STAFF RECOMMENDATION

NCPC File No. 6649

WHITE OAK FEDERAL RESEARCH CENTER
FOOD AND DRUG ADMINISTRATION
CENTER FOR DEVICES AND RADIOLOGICAL HEALTH OFFICE BUILDING
Montgomery County, Maryland

March 30, 2006

VIEW INTO COURTYARD TO NORTHEAST

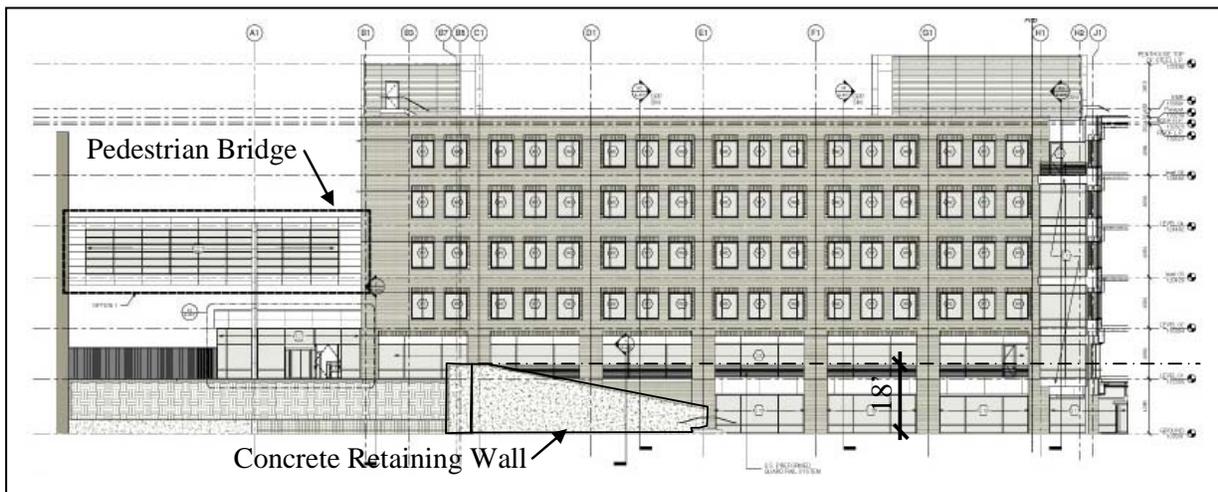
The lack of a landscape design with this submittal has been explained as a result of revised phasing and lack of funding to design or implement landscaping until the final construction phase. That is, the entire north side of campus will not be built out before the south campus as originally planned, and, it would not make sense to landscape that portion of the campus first. Major construction will occur on four sides of a majority of buildings in the future, including lab buildings to the southwest, underground facilities to the south below the commons, and a parking garage to the north. This has led to the acceptance that implementing landscape on a project basis would not be practical or feasible. Typically, efficiency would be gained in the construction by implementing landscaping after major earth moving and excavation activities are complete. Typically, implementing the landscape plan as the last construction phase would eliminate the redundant and wasteful effort to accomplish multiple excavations.

For most of the campus, future construction will surround facilities on all sides. However, the overriding master planning principle is the use of buildings to create a series of pedestrian courtyards and paths, and creation of pedestrian-scale environment with buildings defining landscaped grounds. For the CDRH Building, the major landscaping is envisioned within an

interior courtyard, where it will play a vital role to soften the steep four foot drop in grade and 18 foot high concrete retaining wall and activate the courtyard space into which atrium conference rooms will open. Although not shown on this project submission, designers have told staff that they envision a series of Spanish steps or terraces as landscaping coming down from the Life Sciences Laboratory to form an amphitheater in the courtyard as an oasis from the ongoing construction on the remainder of the campus. Logistically, if basic landforms, both hardscape and landscape, are not created before the courtyard is enclosed, the logic for delaying landscape

on the remainder of campus could backfire. Once the CDRH buildings enclose the courtyard, it would be landlocked, with access limited to openings between buildings, where CDRH meets the laboratory buildings to the southwest. Staff does not object to controlling pedestrian access into the courtyards, but believes that as with the remainder of campus landscaping exterior to the courtyard, it would be premature to implement parts of a perimeter security plan piecemeal without benefit of the entire plan and would be inefficient if not implemented in a later phase with the majority of landscaping. Staff therefore requests that the applicant provide information regarding landscape design and the logistics of its implementation within the CDRH courtyard, and submit the perimeter security plan for the entire campus for Commission review.

Requests the applicant to provide additional information on landscaping for the CDRH courtyard and **on the** perimeter security plan for the entire campus for Commission review.
